**Addendum No. 1**

RE: Contract # C204684

**Haywood County (B-3186, B-5898)**

BRIDGES #155 AND 158 OVER RICHLAND CREEK ON US-23/74 AND  
BRIDGE #168 OVER US-19 AND US-23 ON US-23/74.

NO.	BY:	DATE:	NO.	BY:	DATE:	SHEET NO.
1			3			S2-04
2			4			TOTAL SHEETS 31

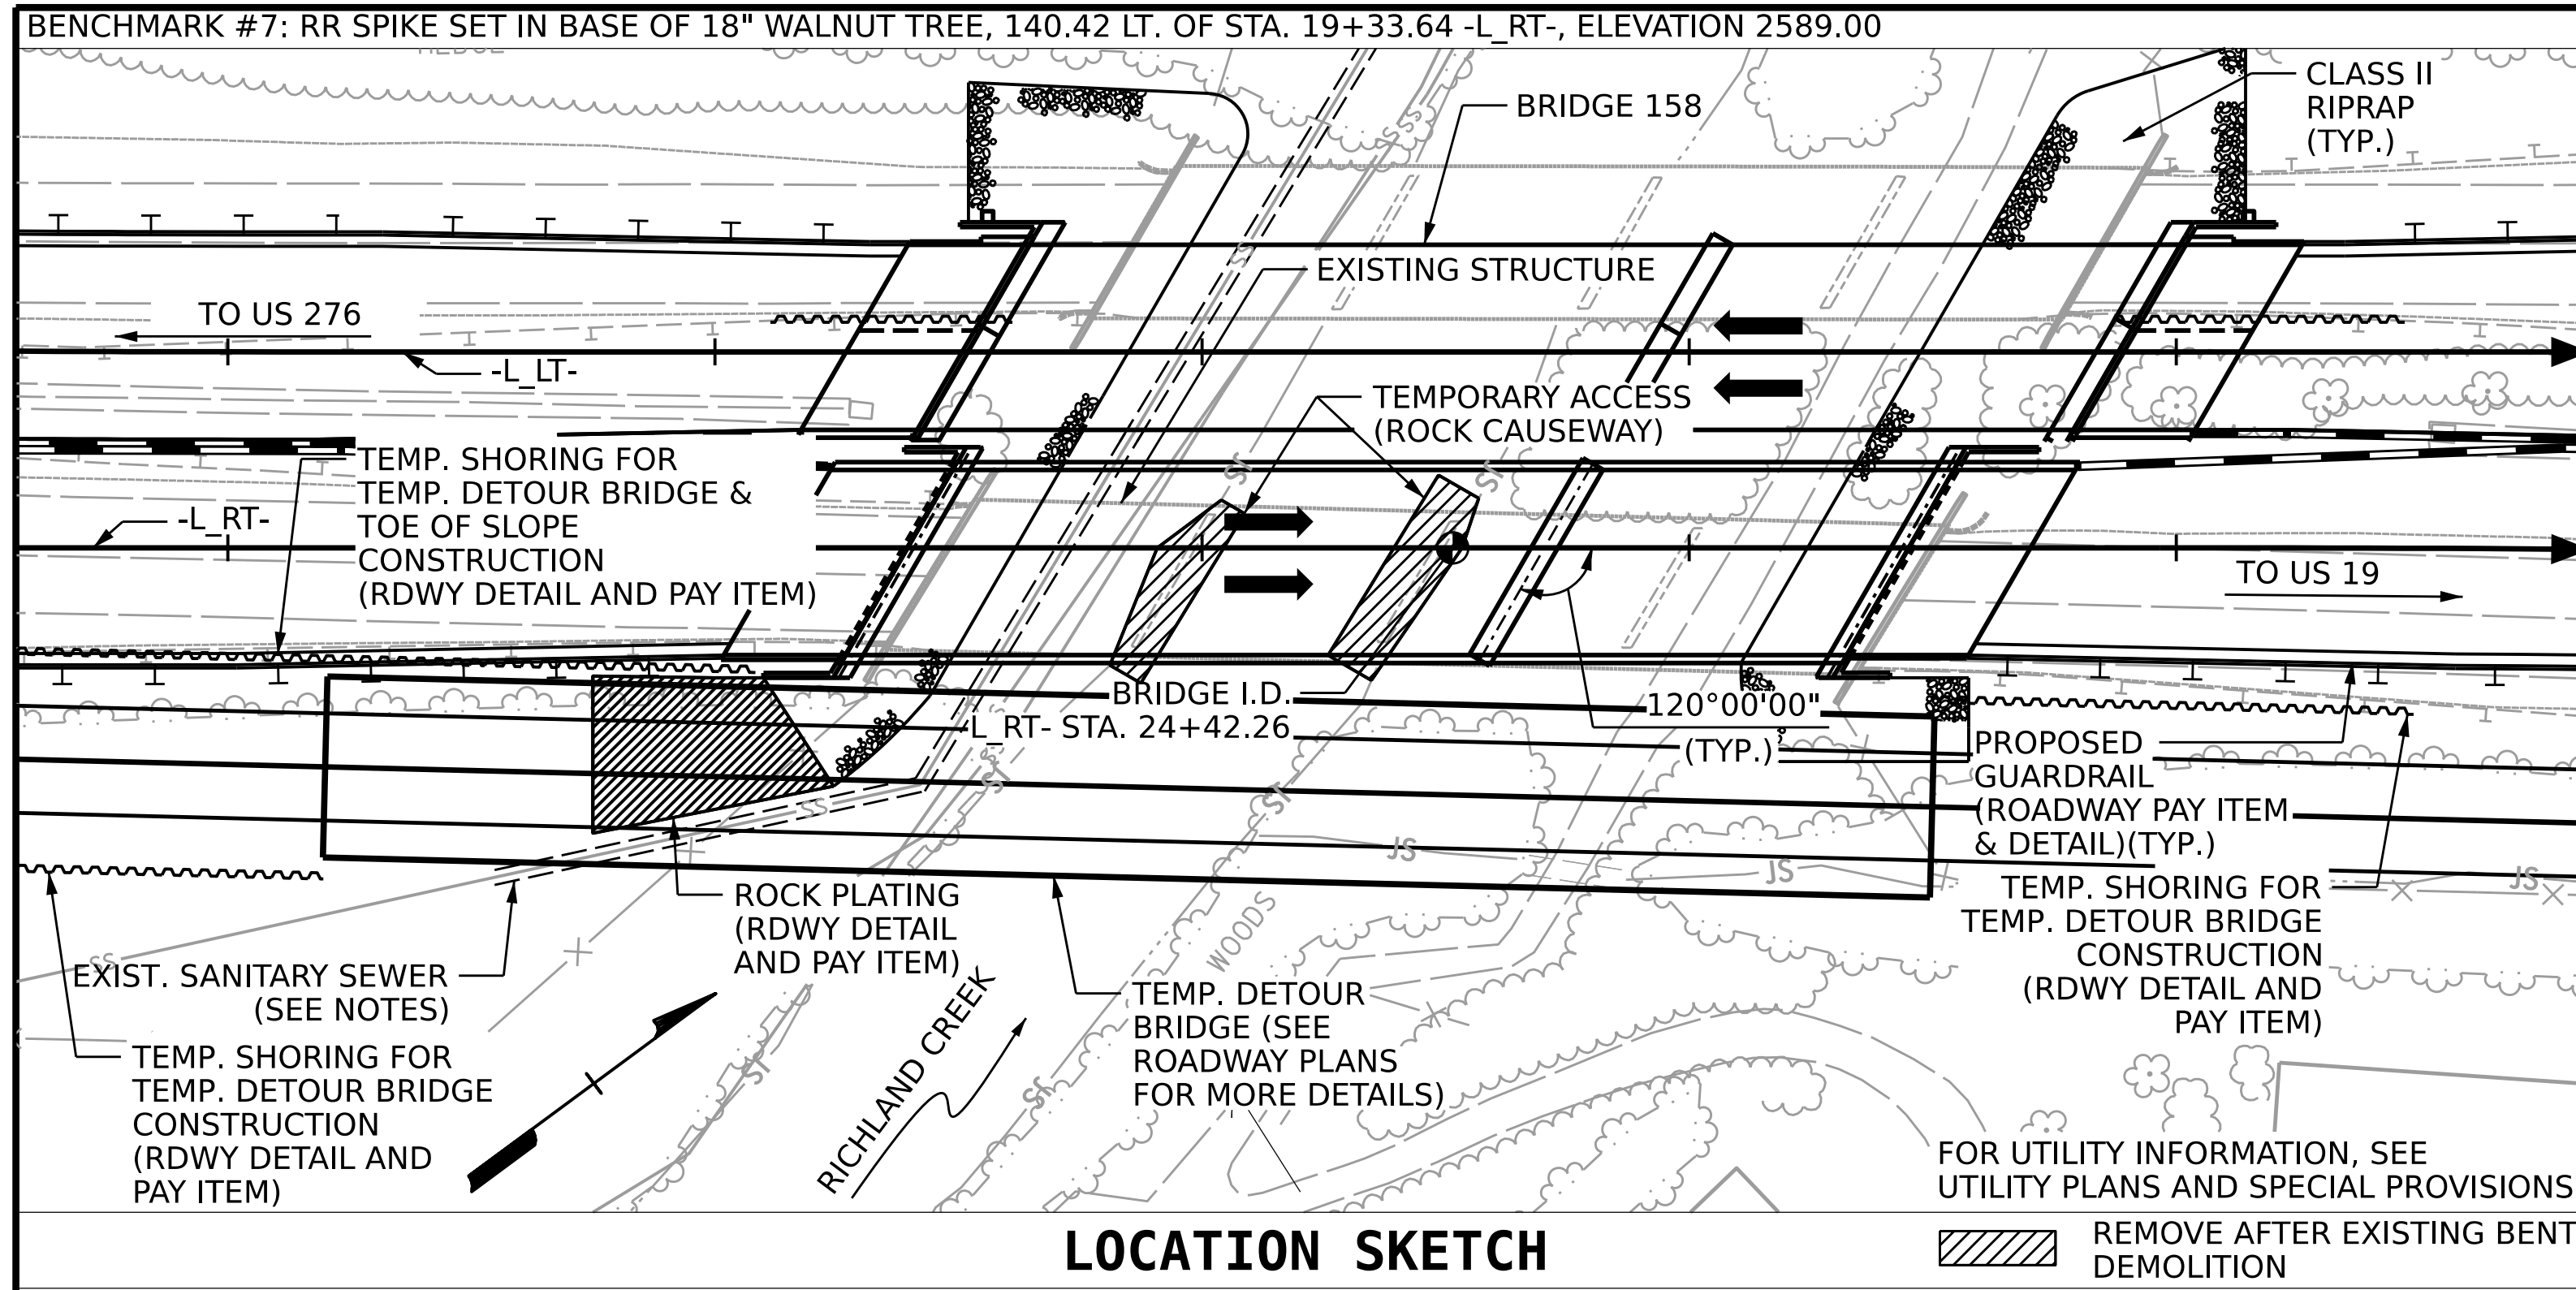
<b>Sheet No.</b>	<b>Revision</b>
S2-04	Note added for removal of existing structure.
